Product Change Notification

PCN-PCC-7629-2022

Business Unit	Product Line Code	Type of Change	Action	Date of Issue
PCC - PCB Connectors	AAA	Product Change Notification	Notify Distributors and Field	1/18/2022

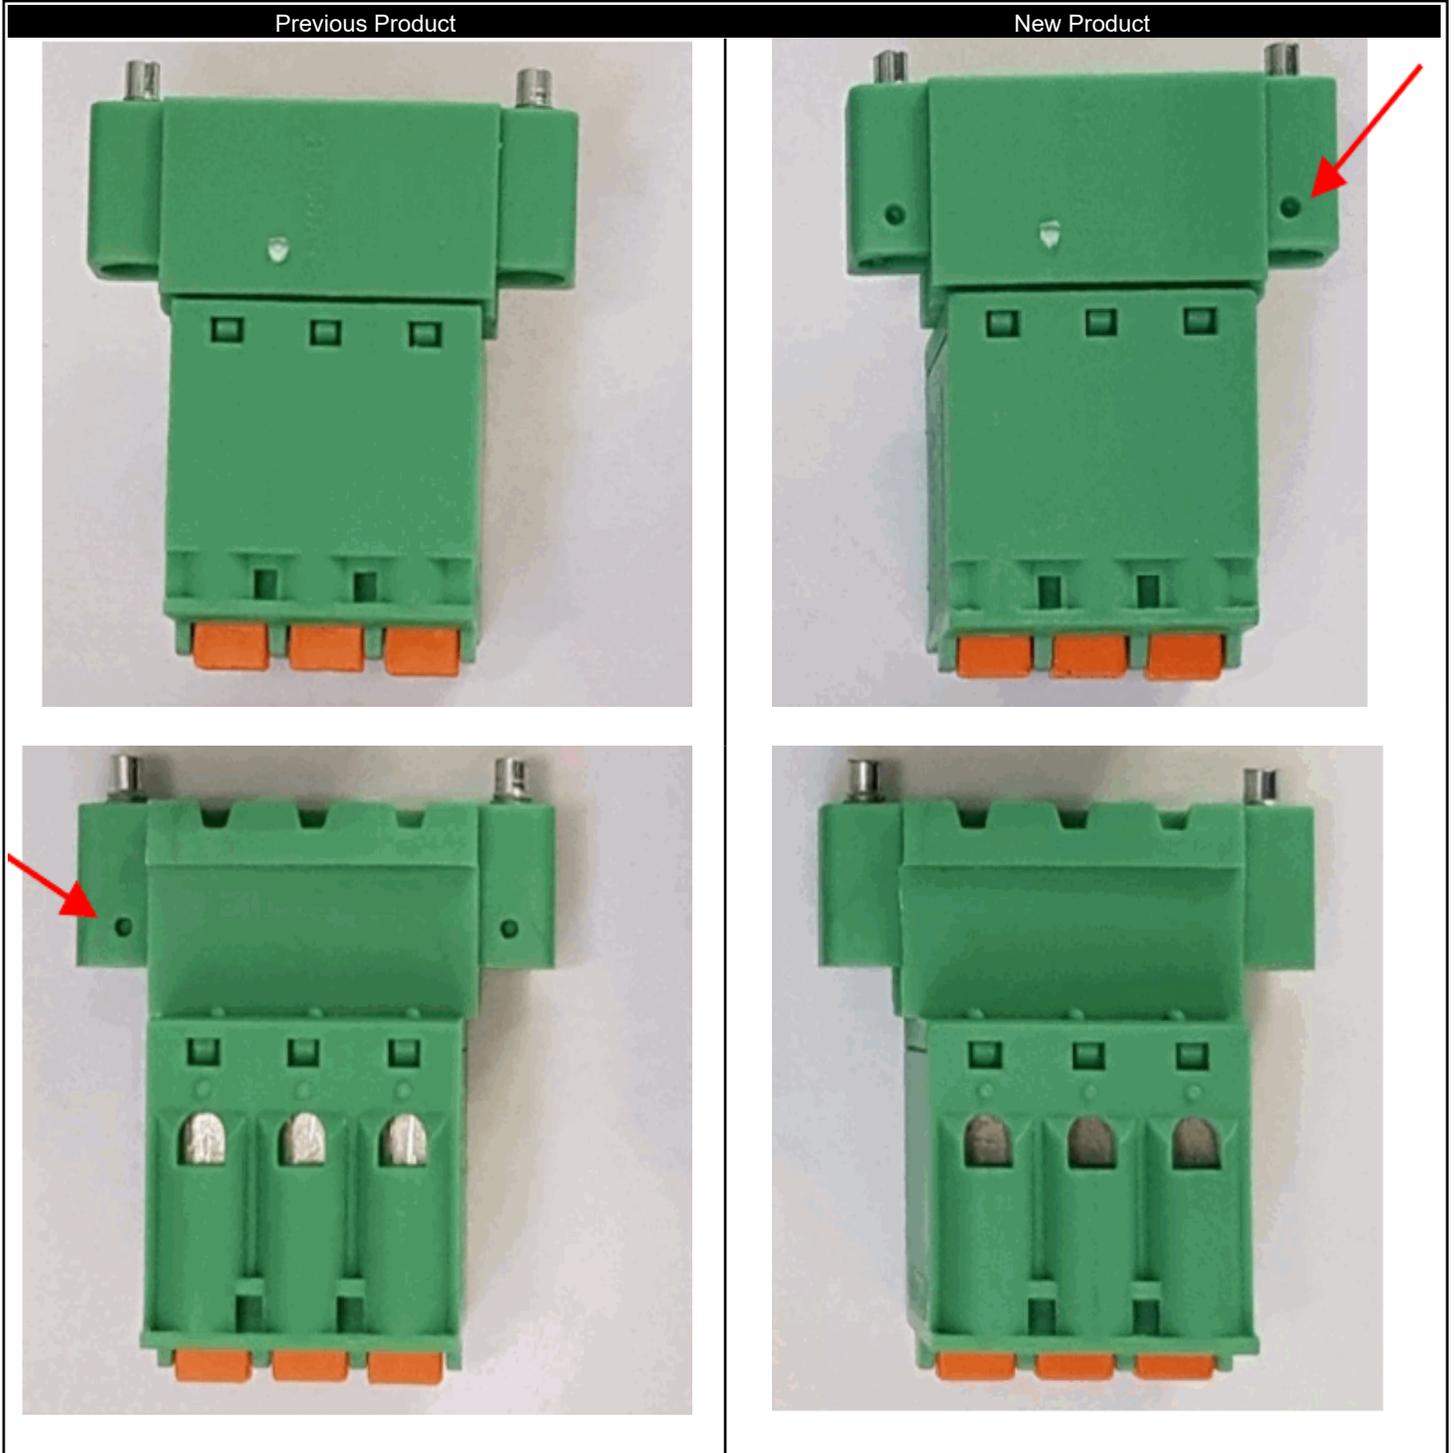
The FKIC 2.5 connector equipment is redesigned as part of the continuous improvement process. The fixing points of the flange screws are marked in the attached comparison of the old/new versions with red arrows. They have been moved from the top of the item to the bottom. There are no changes to the technical data. The batch number of the item will not be increased.
